Architectural Review Board Agenda
Wednesday, May 5, 2021

RE: ARB meeting for May 5, 2021

III. Consideration and possible action on the site plan, architectural plan, lighting plan, landscape plan and sign plan Adron Tool Highlands Business Park.

NEW BUILDING FOR:
ADRON TOOL CORPORATION
BUSINESS DRIVE
VILLAGE OF SUSSEX, WI

LANDSCAPE PLAN

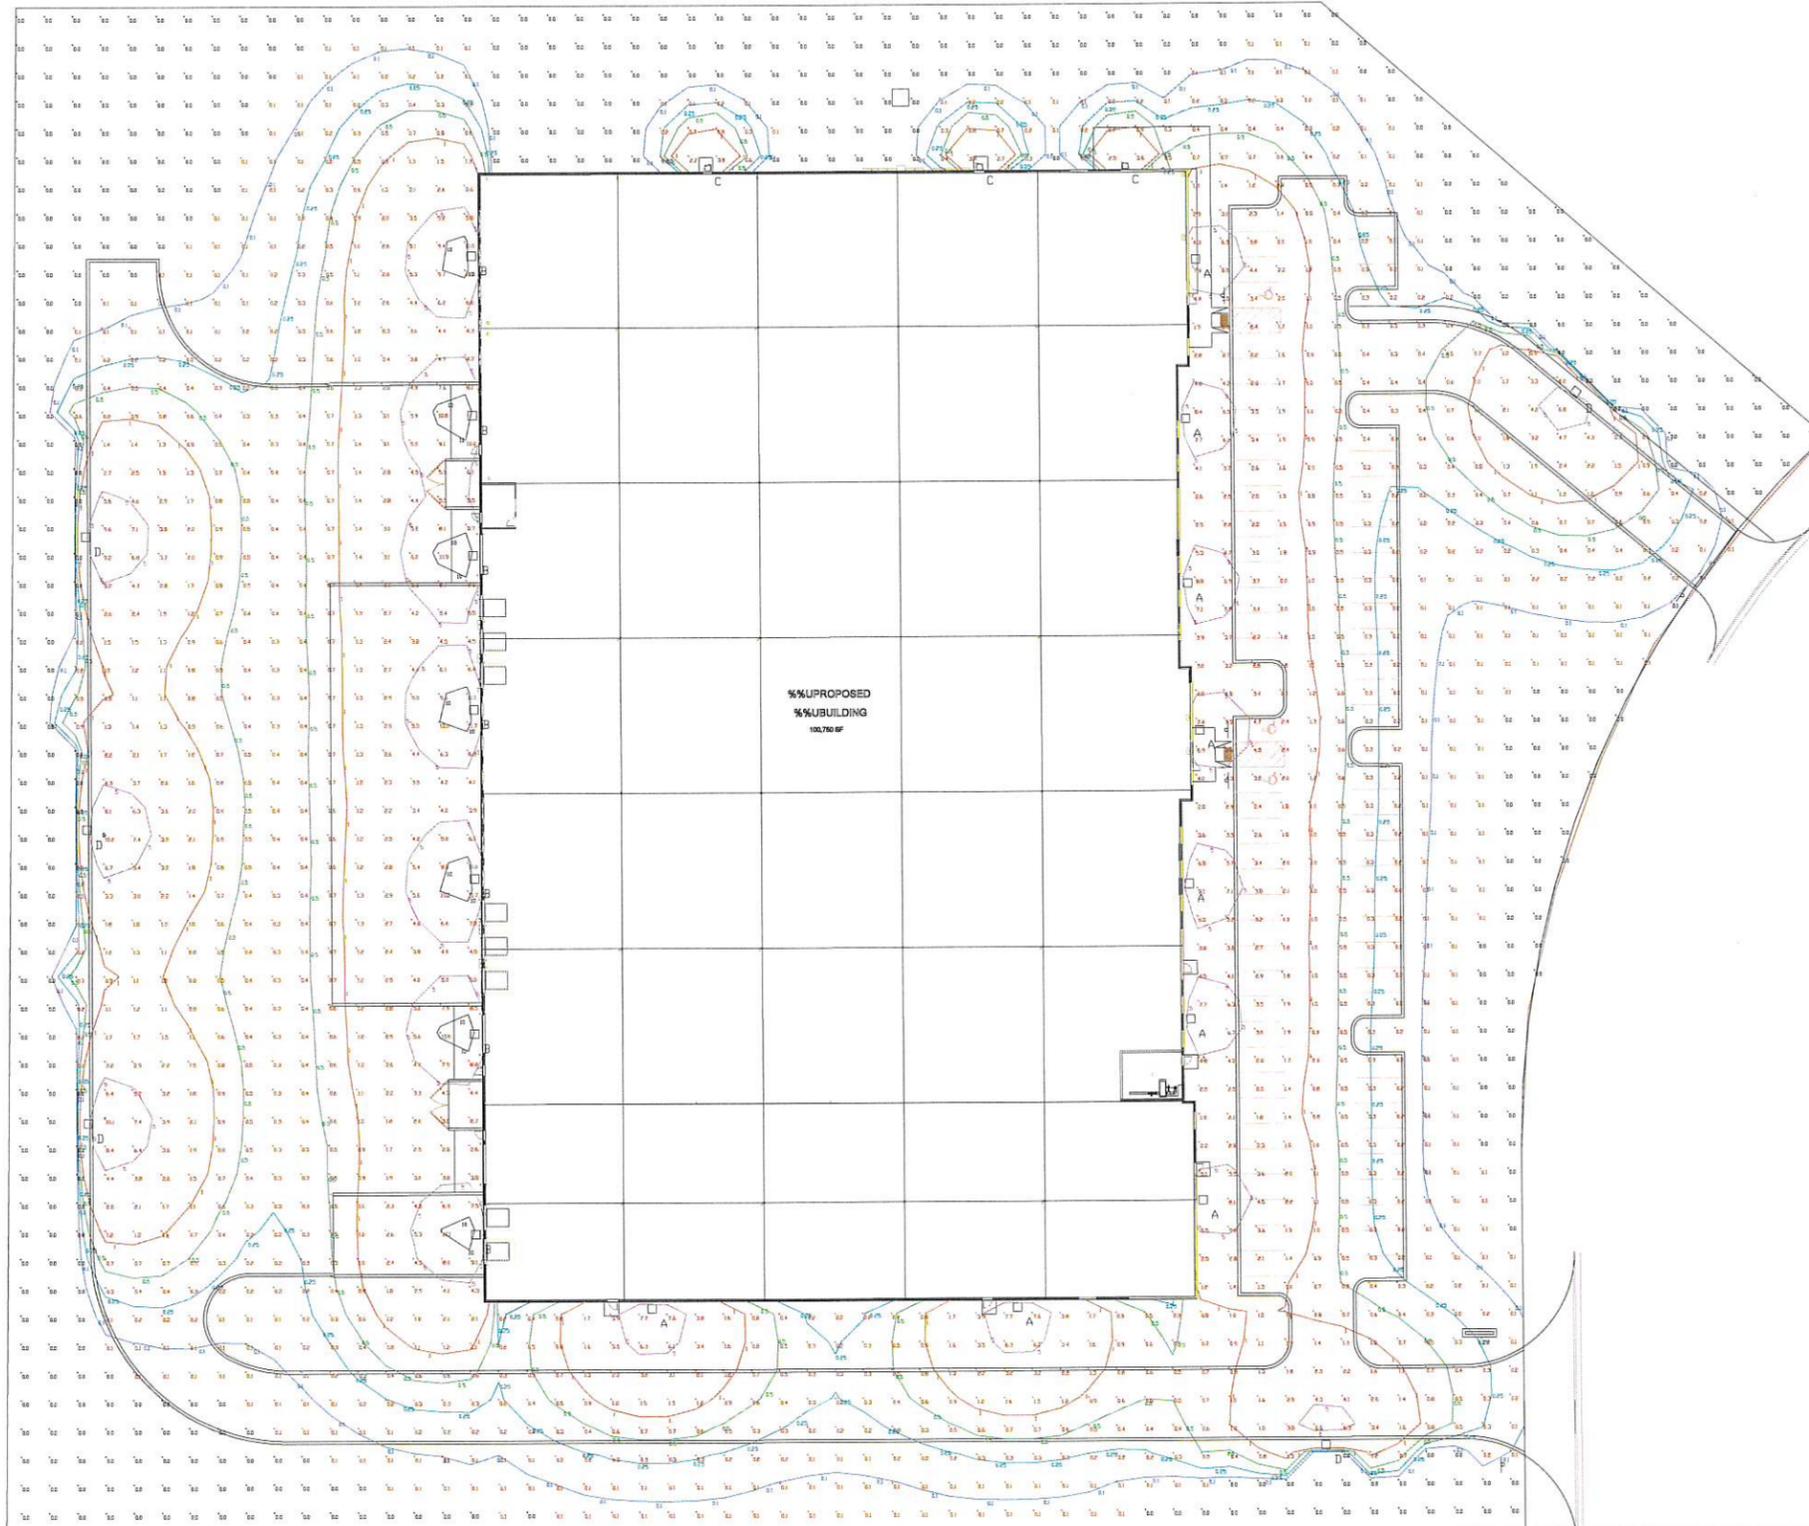
- Site to have 43 trees/evergreens and 749 shrubs/flowers. Should add more evergreen trees at west elevation.

SITE DIMENSION AND PAVEMENT ID PLAN

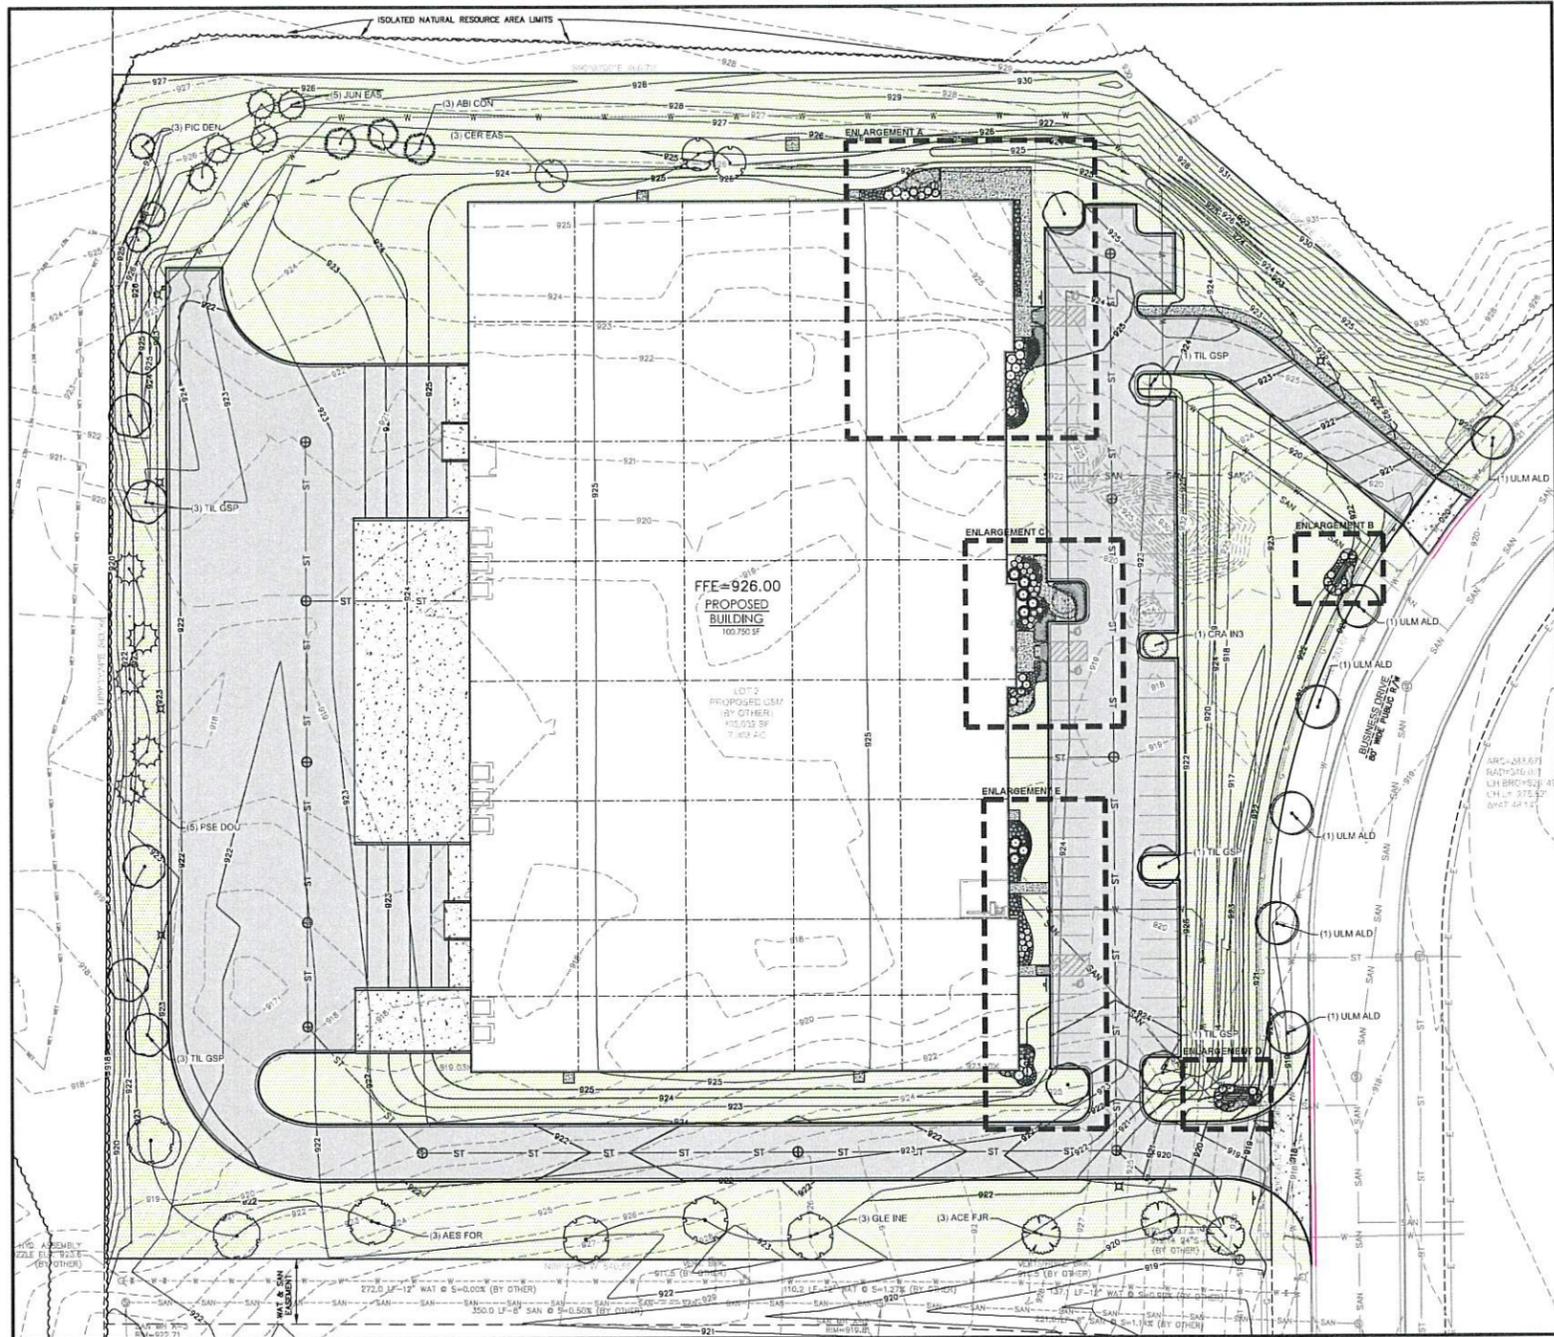
- Add a walkway from the entrance to Business Drive
- Width of driveway opening needs to be adjusted to meet the code requirements
- Curb and gutter needs to be added to the edge of all pavements
- Hydrant easement will be needed
- Site to have 73 parking stalls
- CSM to be recorded

MONUMENT SIGN CONCEPT

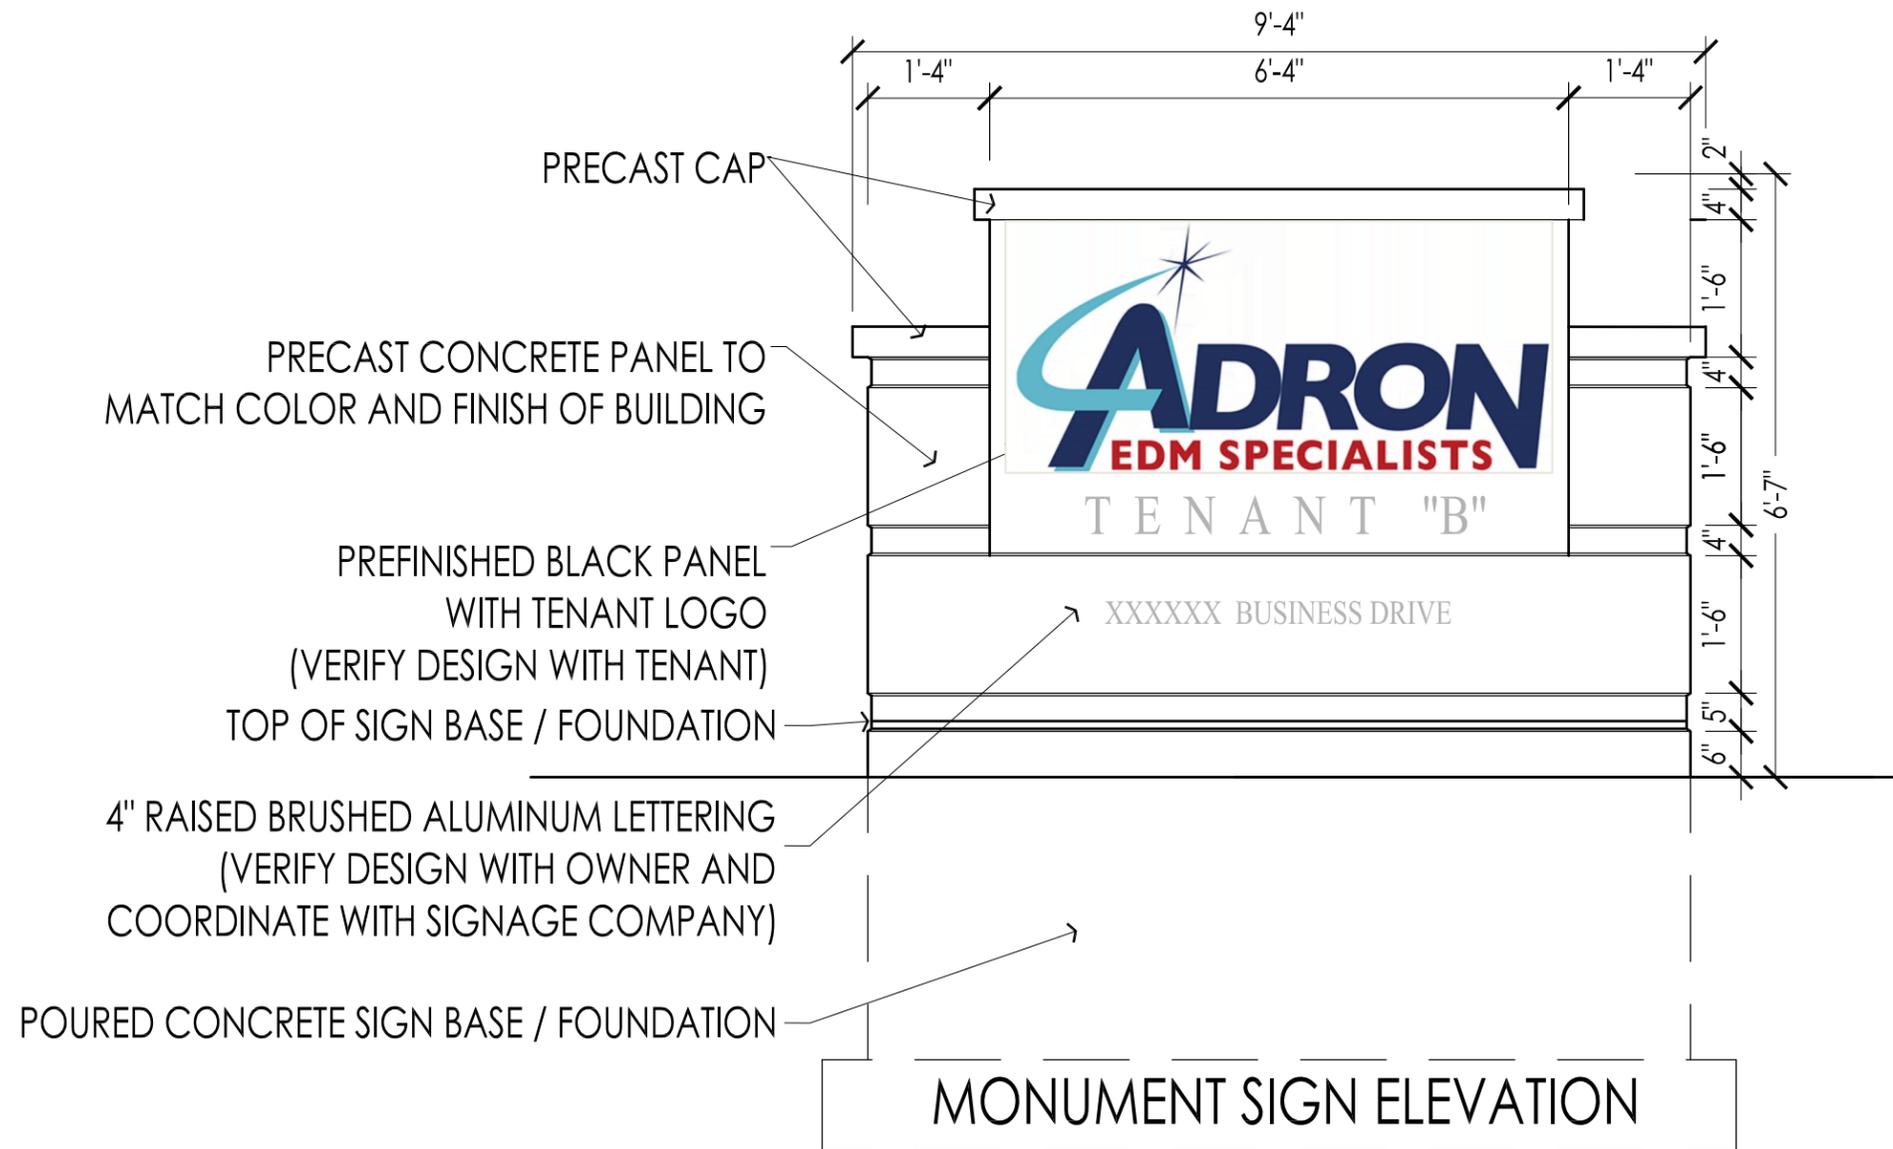
- Base and pillar material needs to match the material of the building
